# 2017 Smog Check Performance Report

This attachment to BAR's 2017 Smog Check Performance Report includes Chapter 3 (only) of the "Independent Review of 2016 Smog Check Performance Report," by Revecorp, Inc., with annotation (*in italics*) to show BAR's responses. Revecorp's bulleted comments refer to BAR's 2016 Smog Check Performance Report and to page numbers in that Report, while citations in BAR's responses refer to the current (2017) Smog Check Performance Report and the pages herein, reflecting BAR's consideration and/or adoption of many of the specific comments and recommendations. The entire Independent Review by Revecorp of the 2016 Report (without annotation) may be found in Attachment C.

This attachment is a copy of the report entitled "Independent Review of 2016 Smog Check Performance Report," by Revecorp, Inc., June 6, 2017.

**Figure 1A - 2015-2016 Roadside ASM Failure Rates for 1976-99 Model Year Vehicles for Initial Smog Check Test Passing and Failing Vehicles Certified at Time = 0 (Source: BAR)**

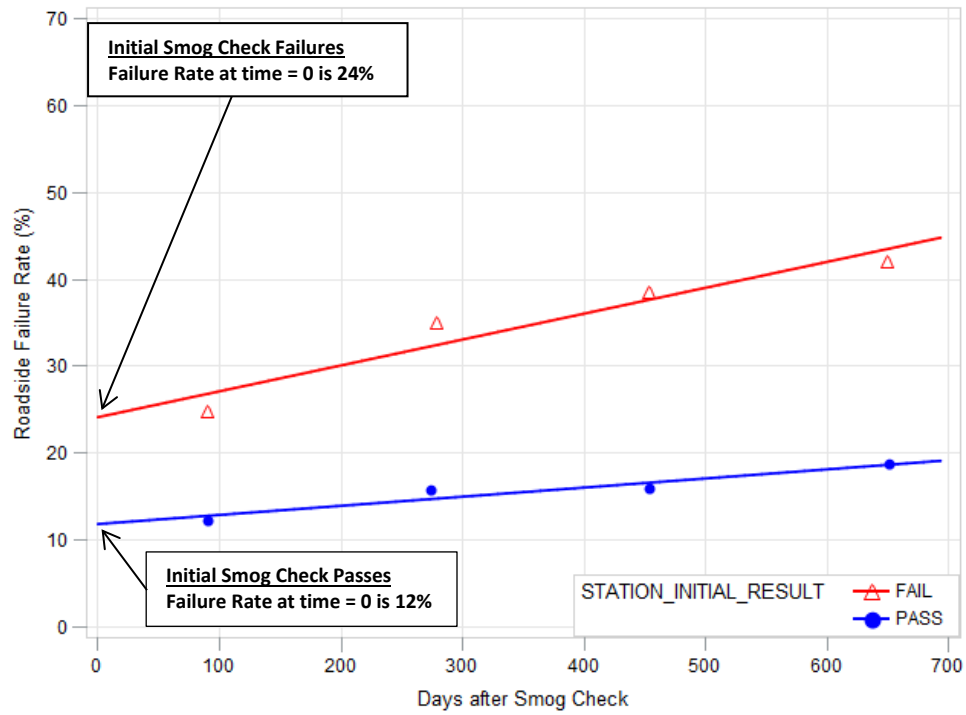
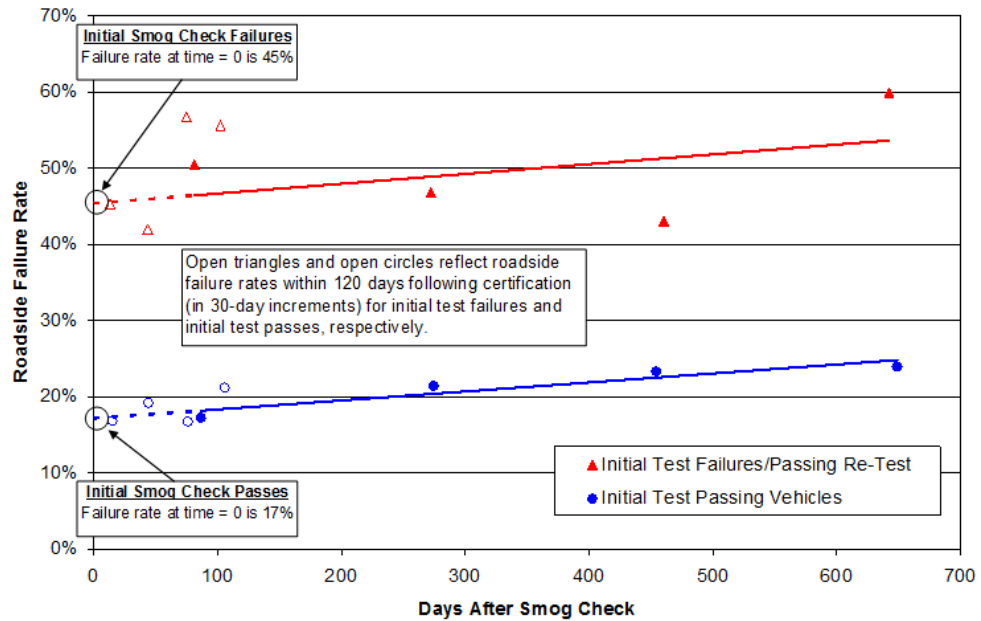
- Comment - Pages 6, 7 and 8 - Figures 1, 2 and 3 – Add error bars and sample sizes to the charts. Also, list the number of stations in each group and the number of inspections performed by these stations so their relative impact can be assessed.

*The numbers of stations, roadside tests and roadside fails in each group has been added to new Figure 2 (pg. 11). In addition, a new Table 2 (pg. 8) has been added which shows numbers of STAR, non-STAR and other stations, along with their respective total numbers of initial tests, failed initial tests, and failure rates. Error bars have not been added to the figure because of the complexity of mixing the weighted and unweighted vehicle counts. Instead, to provide insight into the associated uncertainties of roadside fail rates (and to provide insight into the contributing factors to roadside failures), BAR has provided (pp. 21-23, including Figures B-1 and B-2) initial logistic regression modeling results of roadside fail rates as a function of certifying station FPR scores and time between Smog Check certification and the follow-up roadside test. The vertical range of the shaded band shown in each figure represents the 95% confidence interval for the estimated probabilities of roadside average fail rate. These roadside failure probabilities account for vehicle model year, time between certifying Smog Check test and roadside test, prior initial test result, and FPR. The regression-based estimates of*

**Figure 2: Scenario 1 and Scenario 2 Criteria  
Roadside ASM Tailpipe Failure Rates for Vehicles  
Within One Year of Failing Initial Smog Inspection Prior to Certification  
(Model Year 1976-99 Vehicles)**

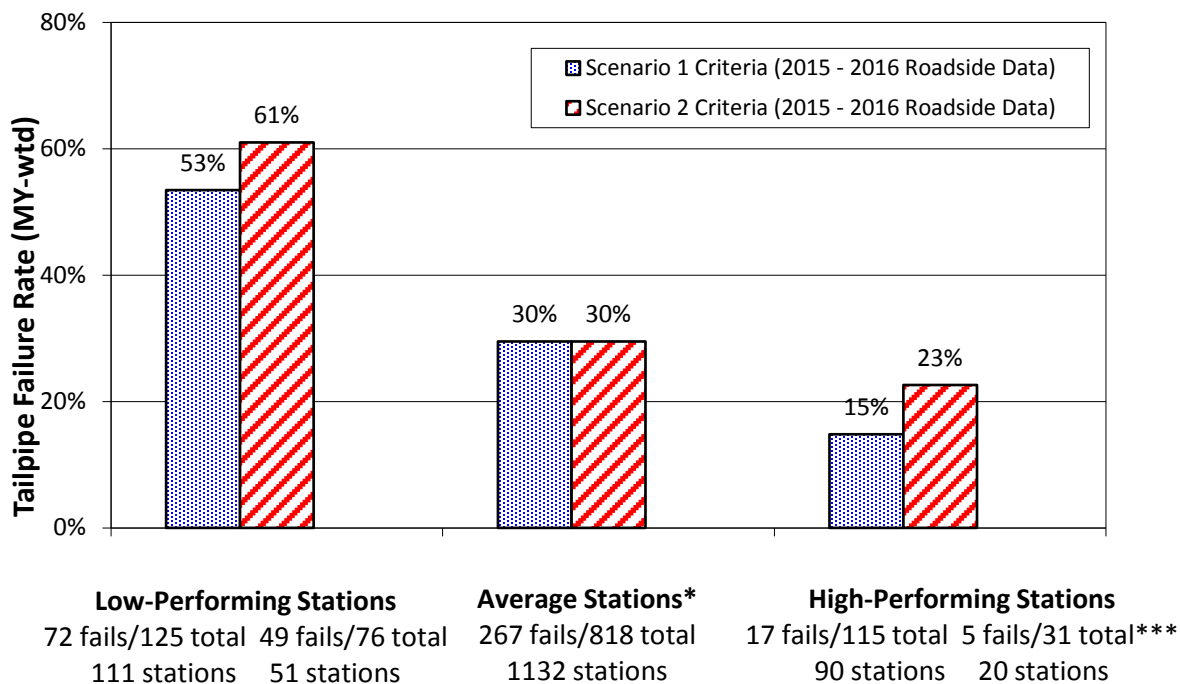
- Comment - Page 8, Figure 3 –Why do the Scenario 2 low-performing stations have higher tailpipe failure rates than the Scenario 1 stations?

**Figure A-1**

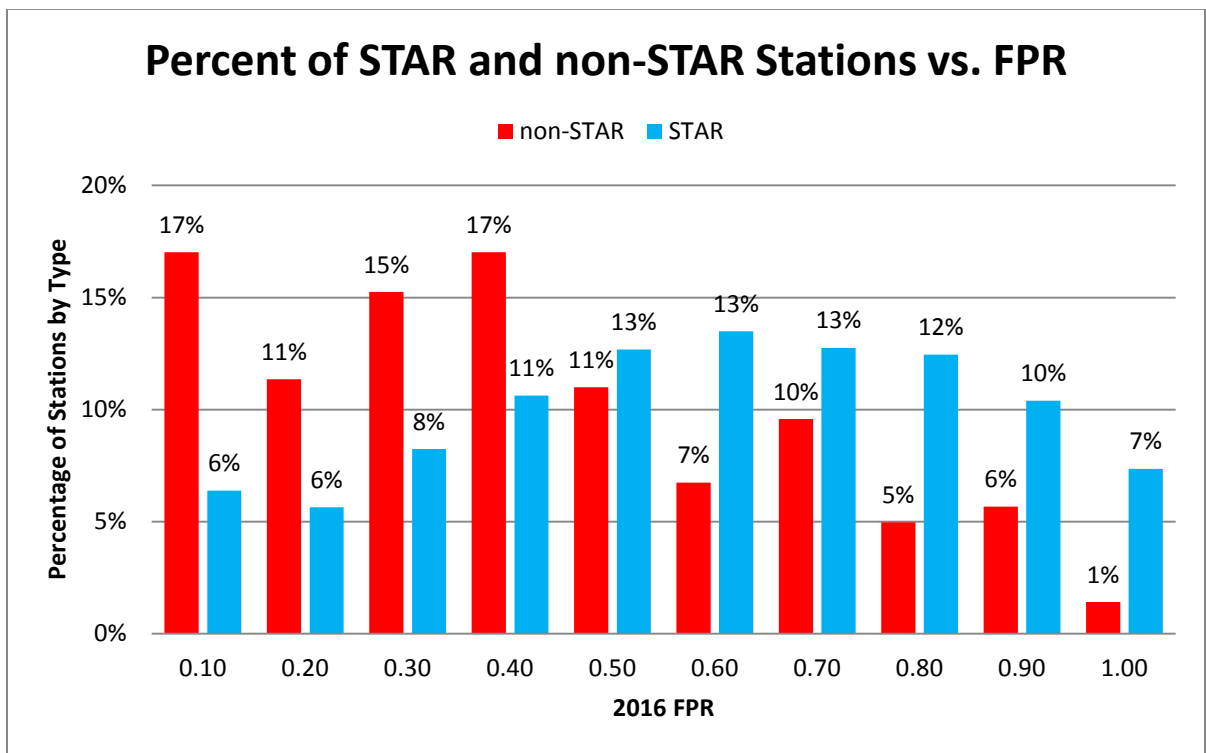
- Comment - Page 7, top paragraph – What fraction of the STAR stations is low-performing? How many low-performing Smog Check stations are longer-term, low-performing and how many are new to the STAR program?

The histogram in Figure A-1 (below) shows the percentages of STAR and non-STAR stations by FPR in calendar year 2016. The mean FPR score for STAR stations is significantly

greater than that for non-STAR stations (even though the more failure-prone older vehicles are directed exclusively to STAR stations). The threshold FPR level at which STAR stations may lose certification is 0.10 and the threshold for non-STAR stations to be certified as STAR (provided that all other requirements are also met) is 0.40. These metrics were selected to provide incentive for testing volume to move from stations having FPRs that are below average, that is, stations which have an FPR of less than 0.50 (like most of the non-STAR

stations) to stations that have an FPR greater than 0.50 (like most of the STAR stations). Finally, it should be noted that only stations which have earned an FPR score are shown in the figure. Stations which have not performed any BAR-97 tests or have an insufficient number of tests to provide a reliable FPR score are excluded from the figure.
